COMMUNITY DEVELOPMENT DEPARTMENT REPORT

HEARING DATE: 9/16/2025

SUBJECT: H-2025-0016
Farrington Heights Subdivision RZ, PP,
MDA

D. Landscape Plan (date: 5/11/2025)

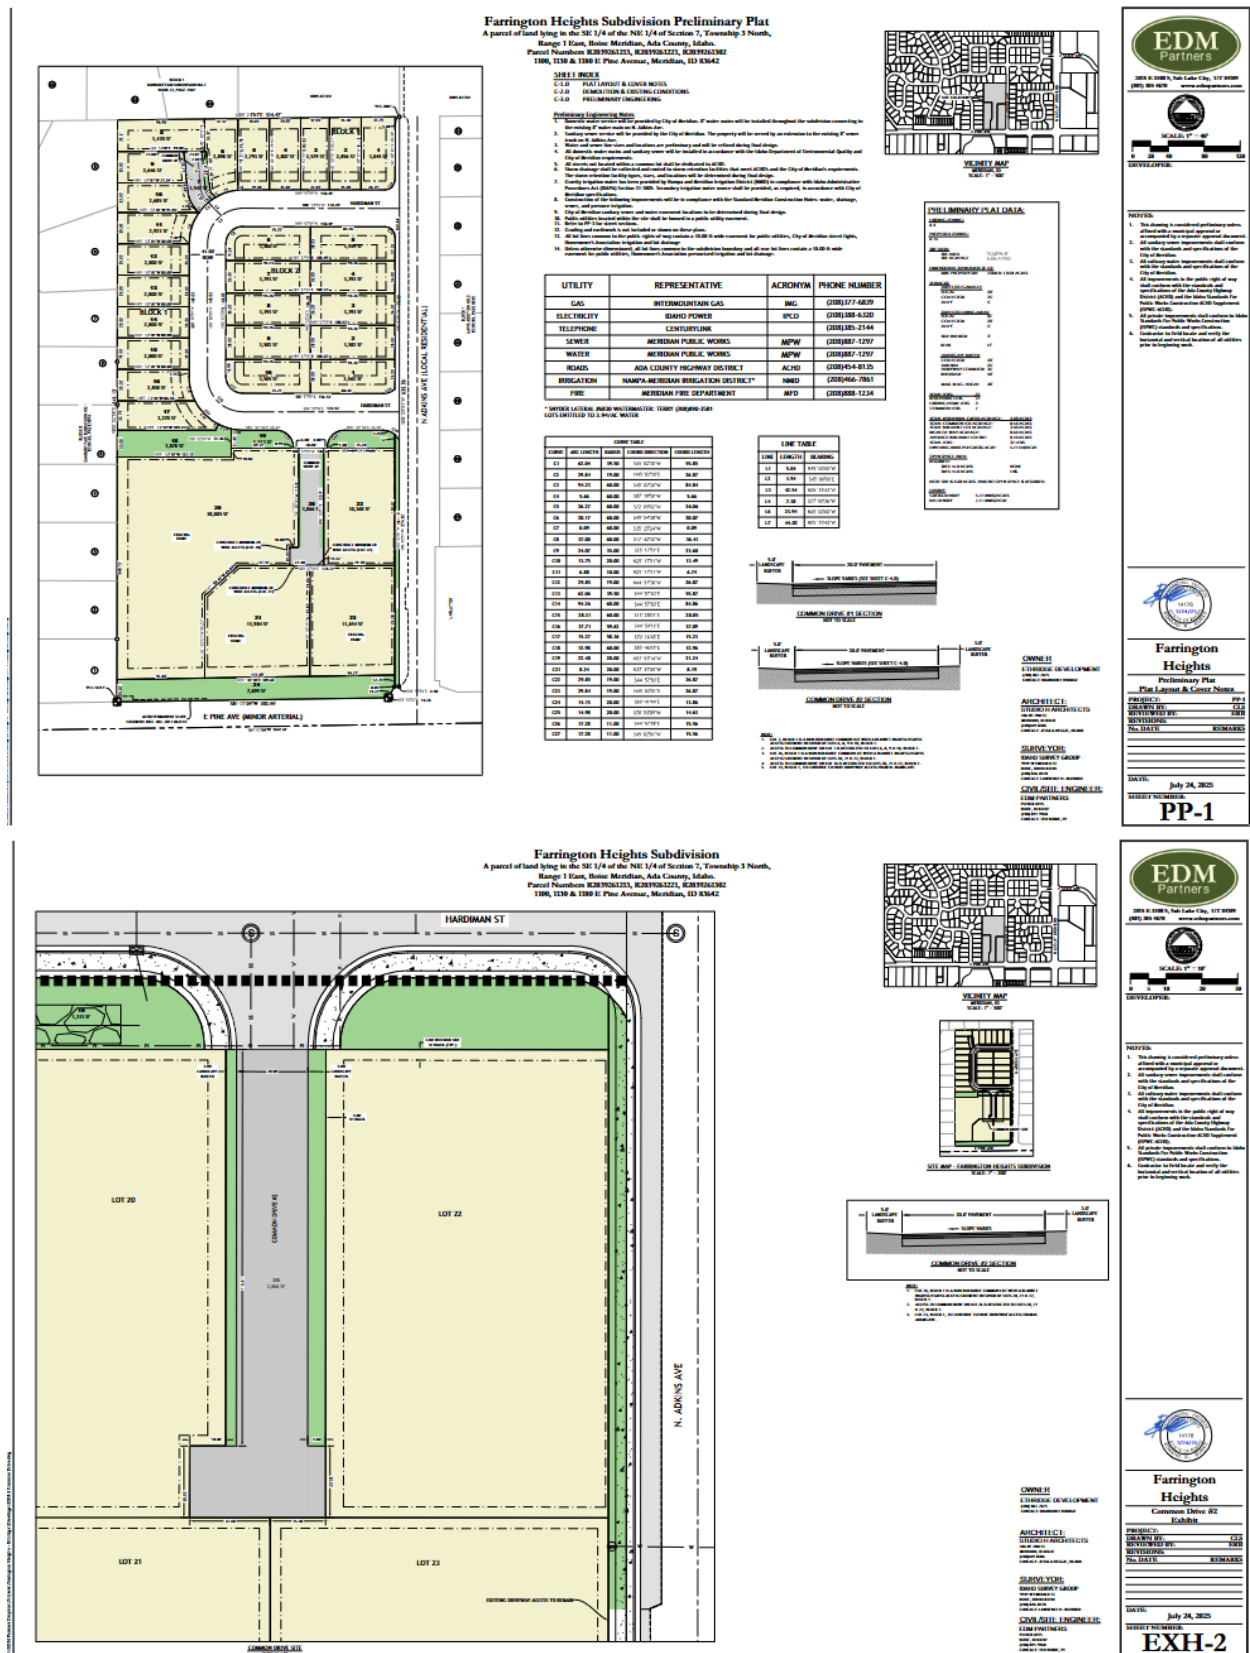
The applicant has provided a twenty-five (25) foot wide landscape buffer along E. Pine Avenue and is required to comply with the dimensional standards for the R-15 district. With the submittal of the final plat, the applicant shall provide vegetation coverage calculations.

The applicant shall provide mitigation calculations with submittal of the final plat if any trees are being removed from the property.

Lot 23 will be taking access off Adkins Avenue. The applicant shall submit an exhibit showing the garage and street setback to the property in compliance with the standards. Lot 23 has an existing home that shall have the necessary twenty (20) foot garage setback and fifteen (15) foot living setback.

All fencing is required to comply with the standards listed in UDC 11-3A-7. According to the submitted landscape plans, the applicant is proposing two types of fencing throughout the site, six (6) foot solid vinyl fencing and a four (4) foot wrought iron semi-privacy fencing.
